Response to R. Jonckheere (AC1)

Richard Ketcham and Murat Tamer

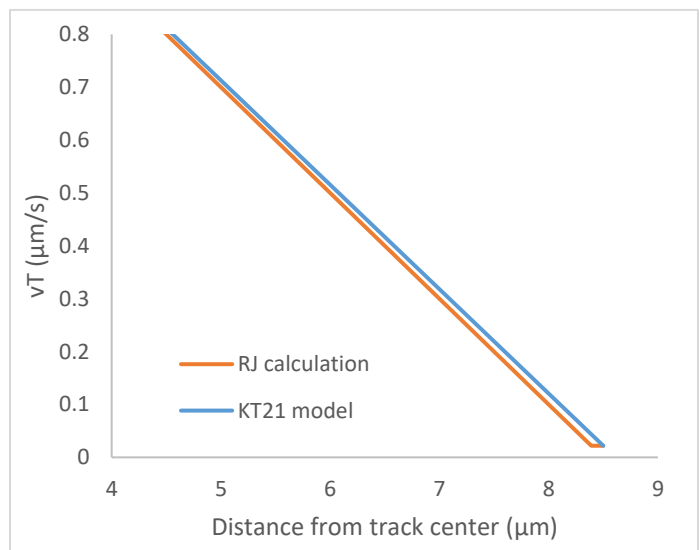
This accommodation is not sufficient to match the KT21 model, as it misrepresents the modeled etch rate along the entire track; the final  $0.11 \mu\text{m}$  should not etch at  $v_B$ , but at a higher rate. When graphed (right) the difference may seem insignificant, but in practice it makes a substantial difference in calculating length as a function of time. To use Dr. Jonckheere's shortcut, the latent length could be increased to make sure the etch rate matches  $v_B$  at the same distance where the KT21 model does, in this particular case  $17.22 \mu\text{m}$  rather than  $17.0$ . In his response, RJ changes the  $c$ -value (rate slope), but it's not clear if this completely corrects the problem; Figure 4 of the response remains incorrect, because the red curve should be at  $v_B$  after  $8.5 \mu\text{m}$ , not at some lower velocity that needs to be corrected.

*"I rederived the equations because I was interested in the preferred linear  $v_T$ -model, and wished not to complicate the equations with  $v_B$ , as  $v_B > v_T$  over  $0.11 \mu\text{m}$  at the ends of unannealed induced tracks. I did, however, consider  $v_B$  in my calculations by setting  $v_T = \max(v_T, v_B)$ ."*

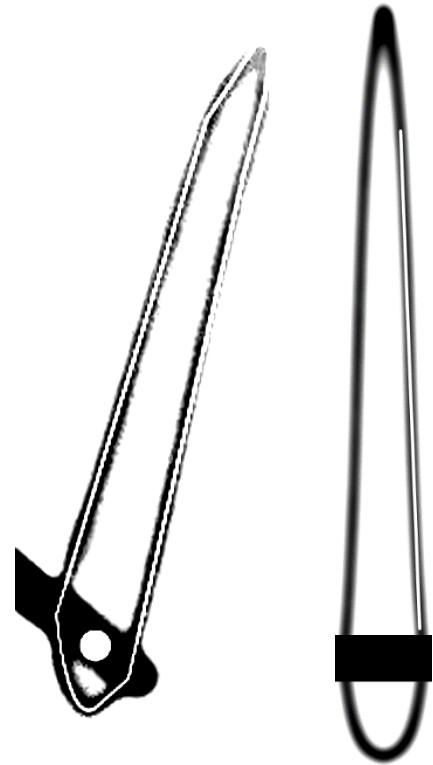
*[line 478-480] ... for example, the white outlines in Fig 9a,b are sometimes on the inside edge of the blurred region, sometimes on the outside edge. One could draw a curved line on the left side of Fig 9b that is a **scaled version of 8c**.*

Unnecessarily curt. For the sake of dialogue, we attempt to roughly illustrate the point. The first diagram to the right is Fig. 9b from the manuscript, with contrast adjusted to emphasize the blurred track edge and interpretive line. If the track were truly straight, it should be possible to draw a straight line that shows the same amount of blurring to either side, or in other words to have the blurred track edge be symmetric about the straight line. This appears hard to do; starting from the bottom and going up, the right-side line begins to the right middle of the blurred region, strays to the right edge, and ends up back toward the middle, implying a very slight curvature. Similarly, the left line also cannot stay squarely in the middle of the blurry track boundary, appearing to go center-left-center-left. On the right, we contrast this with a version of the outer modeled track in Fig. 8c, blurred to approximate the appearance of a track under a microscope. Here, after blocking out the part intersected by the etchant channel, we can also draw a straight line along the simulated track that appears to stay in the middle, and only close inspection shows that it subtly varies its position within it.

Now, these possible appearances of non-straightness in the real track image may be a manifestation of other phenomena, such as refraction, 3D etched track shape, imperfections in the microscope image, variation in track depth, etc. However, it seems clear that very little curvature is really implied by variable along-track etching rates, and within the context of the blurring and noise obtained from even high-quality optical microscopy, it could be missed, especially if one is convinced ahead of time that it is not there.

**No.**
